1. INTRODUCTION

The Port is seeking non-material variations to the project’s Marine Construction Licence in accordance with section 30(7) of the Marine Scotland Act 2010. This document sets out the details of the requested variations and explanation of their non-material nature.

DEEP WATER TERMINAL PROJECT**REQUEST FOR NON MATERIAL VARIATION TO MARINE CONSTRUCTION LICENCE****APPENDIX 1****INDICATIVE DETAILS OF FLOATING LINKSPAN**

REQUEST FOR NON MATERIAL VARIATION TO MARINE CONSTRUCTION LICENCE

DRAWING TITLE
BOLLARD ISLAND GENERAL ARRANGEMENT

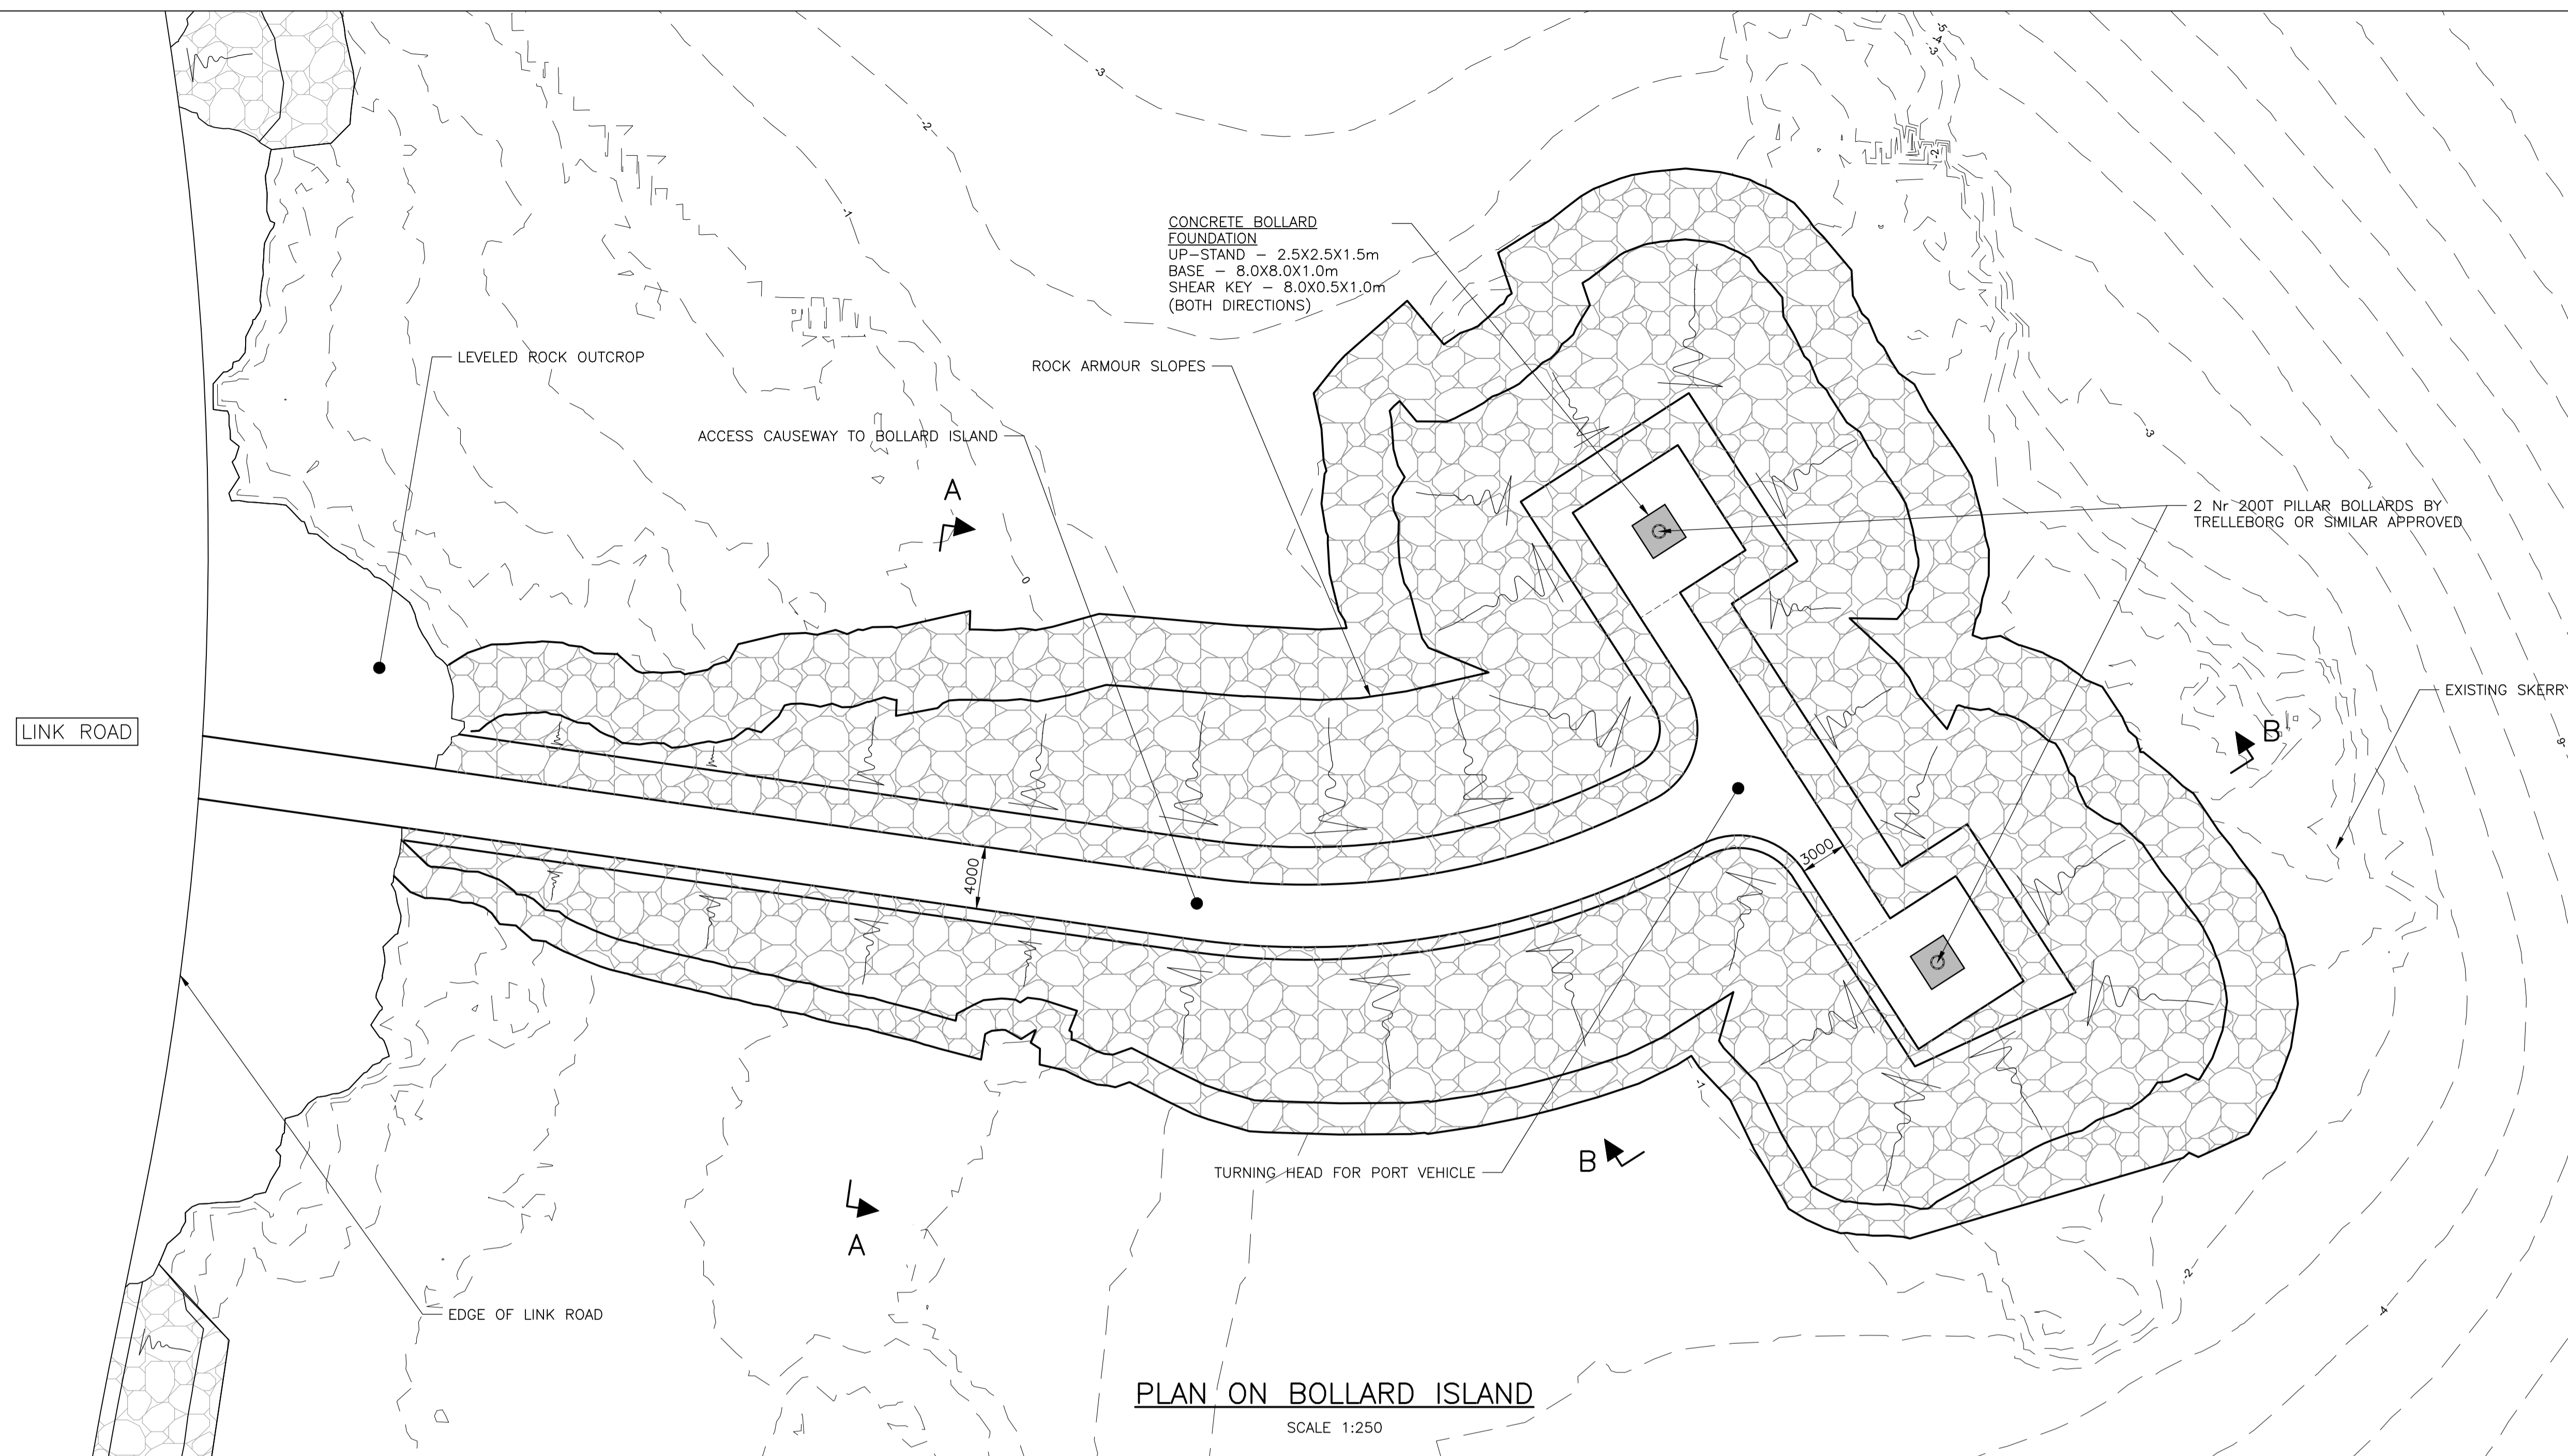
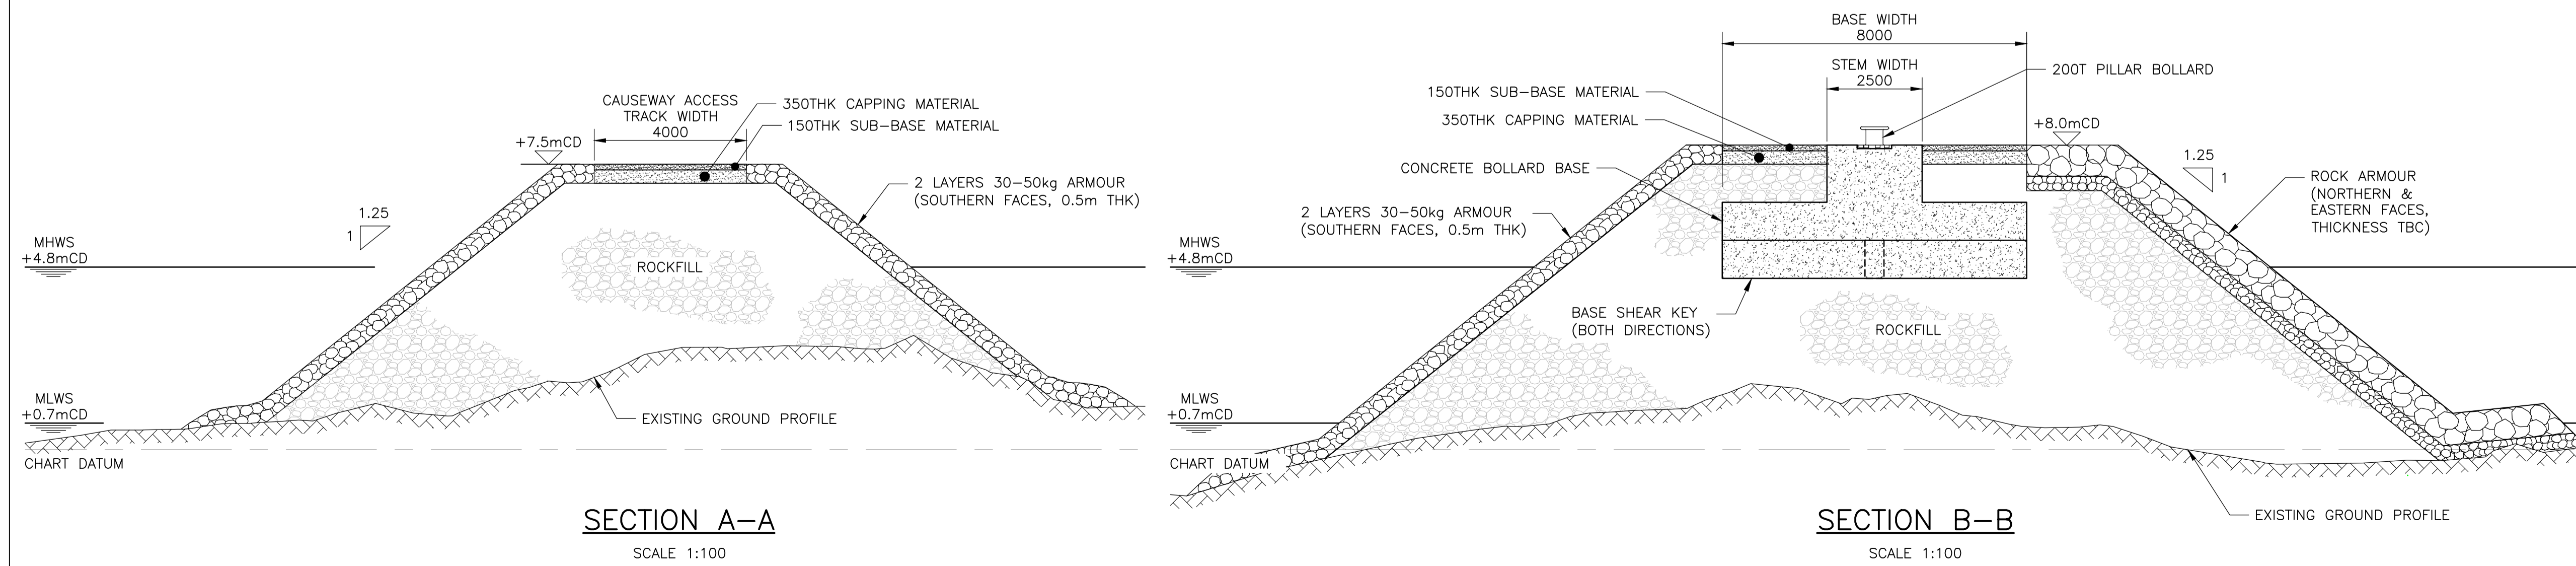
secured to the seabed by steel toe pins grouted with concrete into holes drilled into the bedrock		
2	98m length of finger pier	Open piled 15m wide pier comprising 800mm tubular steel pies driven into the seabed rock driven by vibrating hammer as far as possible, then by impact hammer	18 No. 800mm diameter steel piles	The finger pier was omitted following a design review, which identified that only part of the finger pier was required.
3	Bollard island	Bollards secured to rock outcrops with 4m access causeway approximately 100m long formed of rock bund protected by rock anchor	Rock fill Rock armour	Plan of bollard island included at Appendix 6.
